VILLAWOOD

Project address: 1 Villawood Place, Villawood

Drawing title: CROSS VENTILATION

Project no. 923 Dwg #. A450

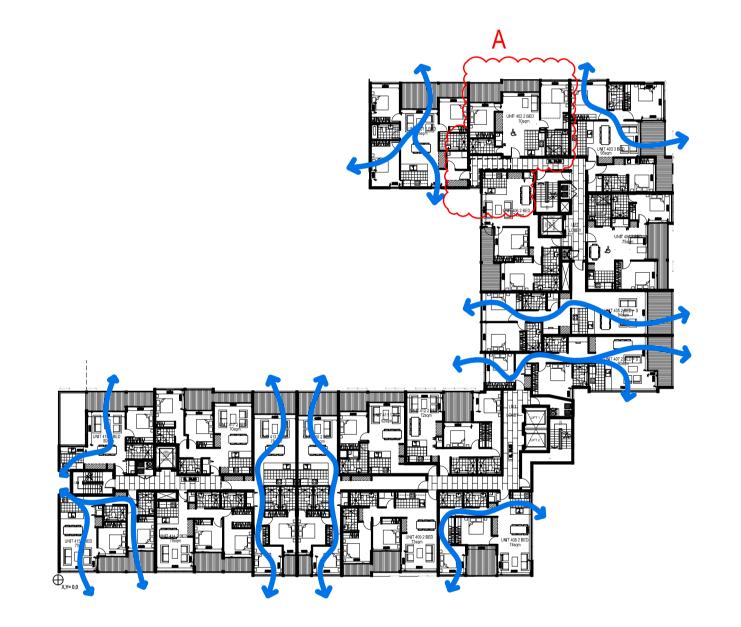
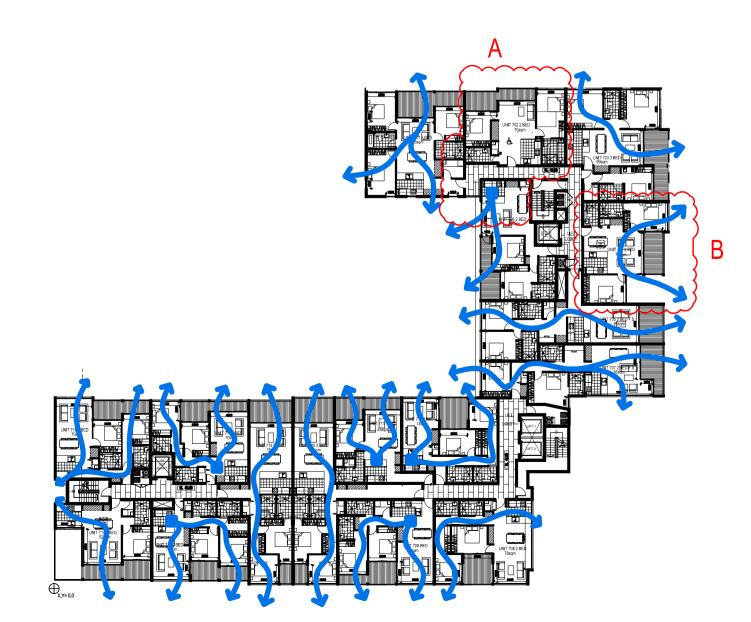
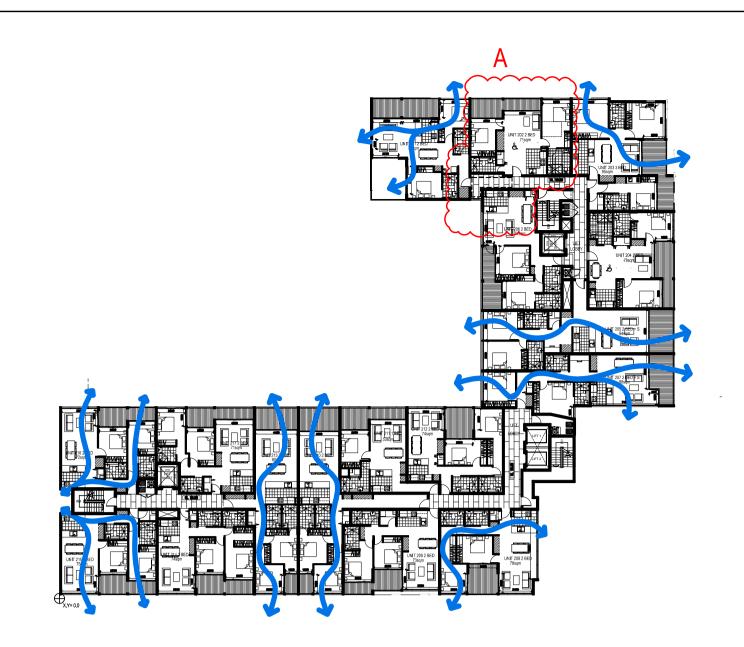
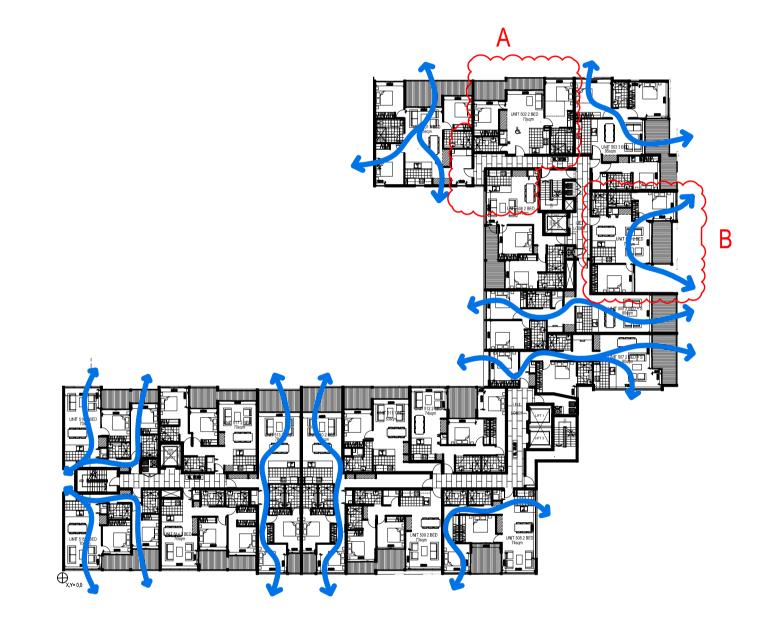
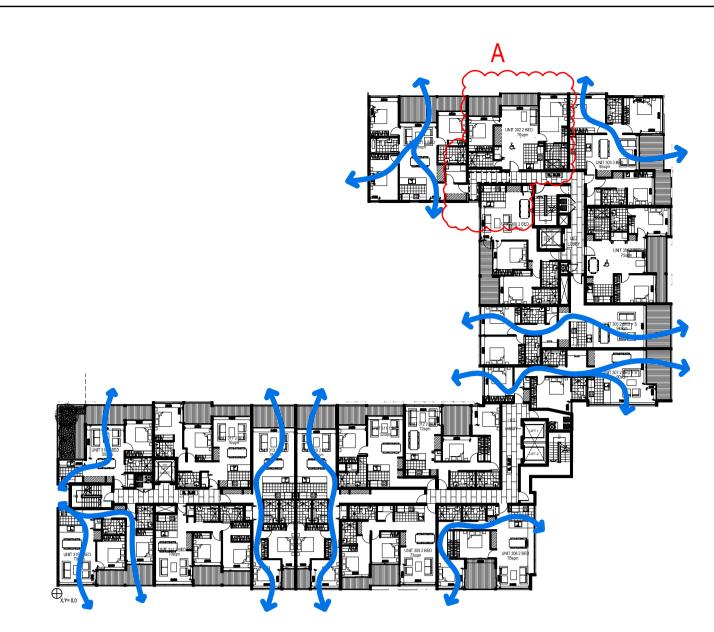
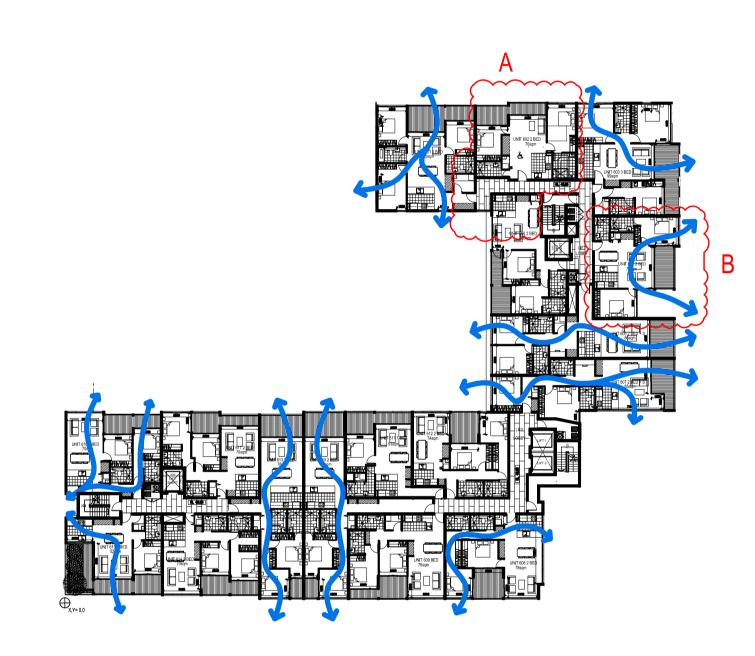
CROSS VENTILATION AMENDMENT:

A. VENTILATION PLENUM REMOVED FROM UNITS 102, 202, 302, 402, 502, 602, 702

B. VENTILATION SHAFT ADDED FOR UNITS 504, 604, 704
